APPLICATION NO.	FILING DATE	FIRST NAMED INVENTOR	ATTORNEY DOCKET NO.	CONFIRMATION NO.
10/561,999	12/23/2005	Mary E. Fortuna	US030213	1348

Office Action Summary	Application No. 10/561,999	Applicant(s) FORTUNA ET AL.	
	Examiner Aaron Williams	Art Unit 2889

DETAILED ACTION

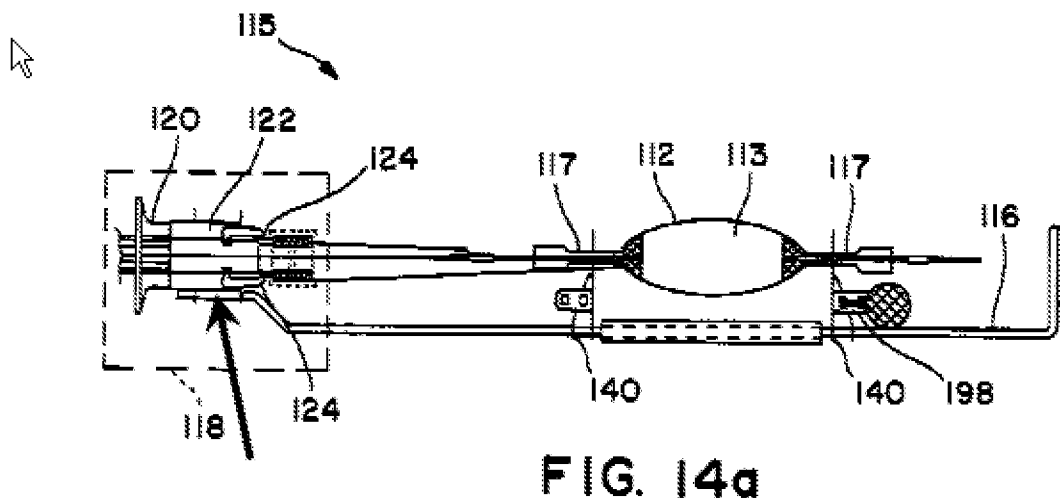
Regarding claim 1 Hassink discloses in figures 1 – 2, **In an electric lamp having a power of about ≥ 175 W to about 400 W** (Lamp assembly (A) disclosed as in column 2 lines 51 – 56) , **a light source capsule** (arc tube (11)) **energizeable for emitting light and including a generally planar seal sealing said capsule in a gas-tight manner, said seal having two generally parallel major faces and two opposing minor faces extending transversely between said major faces** (refer to column 3 lines 45 - 56), **a stem portion and at least one support rod extending adjacent a minor face of said seal** (in figure 1 the support rod includes first conductor

wire (33) fits this limitation with reference to column 4 lines 5 – 25 which explains that the present invention orientation can be changed such that this limitation can be met), **the improvement wherein said lamp** (Lamp assembly (A)) **has a strapless mount structure comprising a main frame portion** (figure 1 shroud mechanical support means (13) including shroud (12) and first conductor wire (33) and second conductor wire (34) fully describe in column 3 lines 64 - 67); **a first metallic support rod** (stem lead (22) column 3 line 22) **extending from said stem** (glass stem (20) column 3 line 16) **portion and fixed** (by connecting to lead (33)) **to said main frame portion; a second metallic support rod engaging said dome** (lead (33) engages dome (19) a part (38)) **end of said envelope and fixed to said main frame portion**, but fails to teach **and a support clip attached at one end to the lower end of the arc tube press, and at a second end to the stem wire or to a frame portion connected to the stem wire or to a portion of the main frame**. However Hassink does disclose that his invention could be made with a closed type of structure, i.e. without a shroud, in column 2 lines 1 - 5.

Johanning teaches two frame structures one of the frame structures in figures 13a – 17b shows a support clip (figure 14A tube clip (140)) attached to the stem wire to and to the arc tube (112). Johanning provides motivation to combine in column 9 lines 10 -13 and 43 – 45. Where he states the tube clips (140) provide mechanical support to arc tube (112) and prevent axial movement of the arc tube (112).

It would have been obvious to one of ordinary skill in the art at the time of the invention was made to modify Hassink's arc tube structure with the support clips of

Johanning to increase mechanical stability. Both the Hassink's and Johanning's invention are in the same field of endeavor (high intensity discharge lamp) and are directed to the same problem sought to be solved (optimizing the support structure of HID's lamps).

FIG. 17a

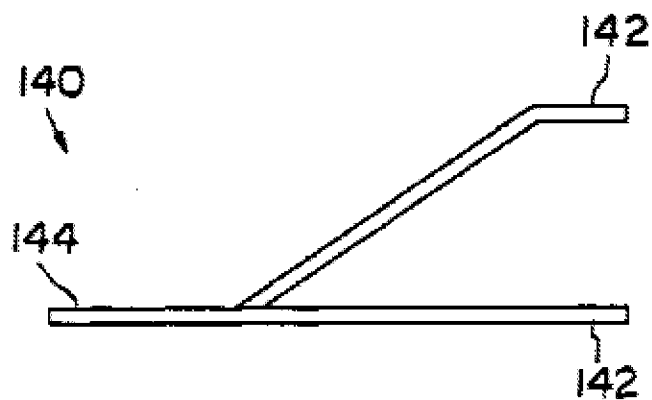
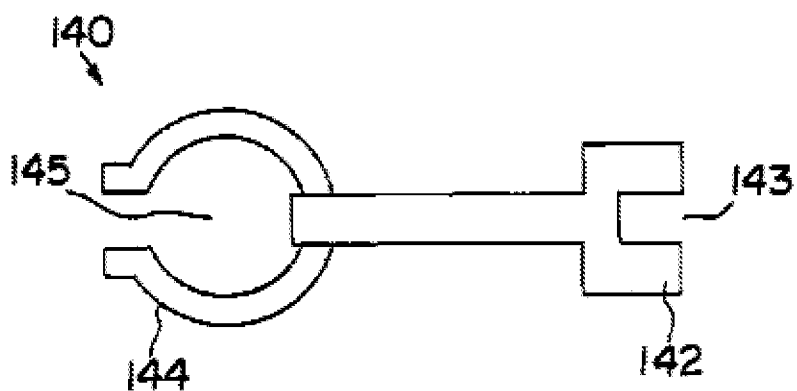
Regarding claim 5 Hassink discloses and Johanning teaches, **An electric lamp as claimed in claim 4, Johanning further teaches wherein the horizontal clip is attached at a second end to the a portion of the main frame.** Refer to the picture below and column 9 lines 10 - 15 and 43 – 45 where support clip (140) is described.

(143) Holds portion (130) of
frame (116)
(145) Holds portion (117) of arc
tube (112)

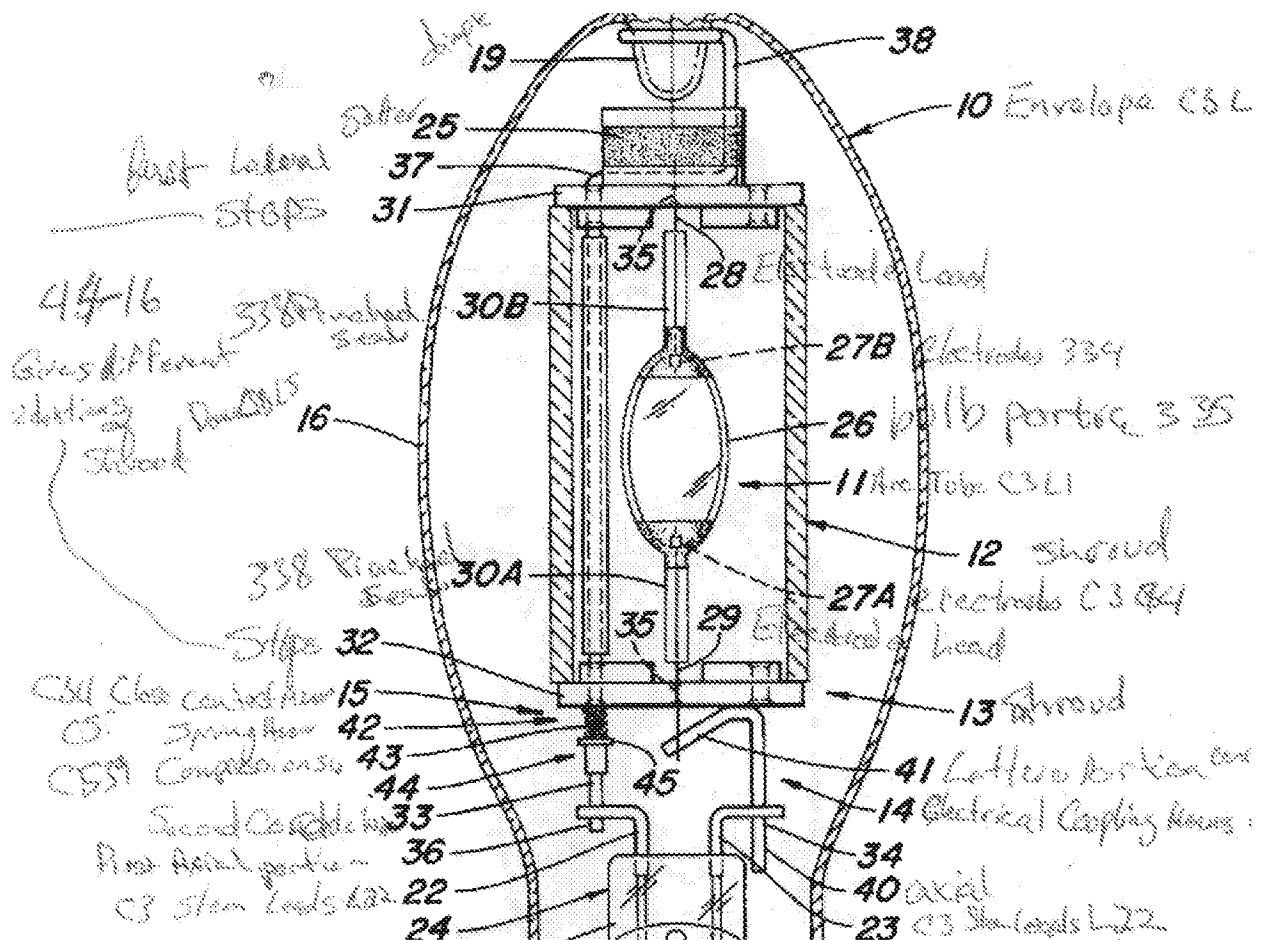
Regarding claim 6 Hassink discloses and Johanning teaches, **an electric lamp as claimed in claim 1**, Hassink further discloses **wherein said light source capsule is electrically connected in said lamp in the absence of a field wire**. Refer to the picture below where there is no field wire shown. Further the use field wire is not necessary in Hassink's invention because the conductive wires (33, 34) are electrically connected to the stem mount through stem lead wires (22, 23).

Regarding claim 9 Hassink discloses and Johanning teaches, **an electric lamp as claimed in claim 1, 2 or 4,** Hassink further discloses **wherein said lamp is a high pressure discharge lamp and said light source capsule is a discharge vessel having a press seal at opposing ends thereof, discharge electrodes arranged within said discharge vessel, and a discharge sustaining filling in which a discharge is maintained between said discharge electrodes during lamp operation.** Refer to column 3 lines 30 – 43 where the third picture in the present office action described.

Regarding claim 11 Hassink discloses and Johanning teaches, **A high pressure gas discharge lamp as claimed in claim 10**, Hassink further discloses **wherein said light source is electrically connected in said lamp in the absence of a field wire**. Refer to the third picture, in the present office action, where there is no field wire shown. Further the use field wire is not necessary in Hassink's invention because the conductive wires (33, 34) are electrically connected to the stem mount through stem lead wires (22, 23).
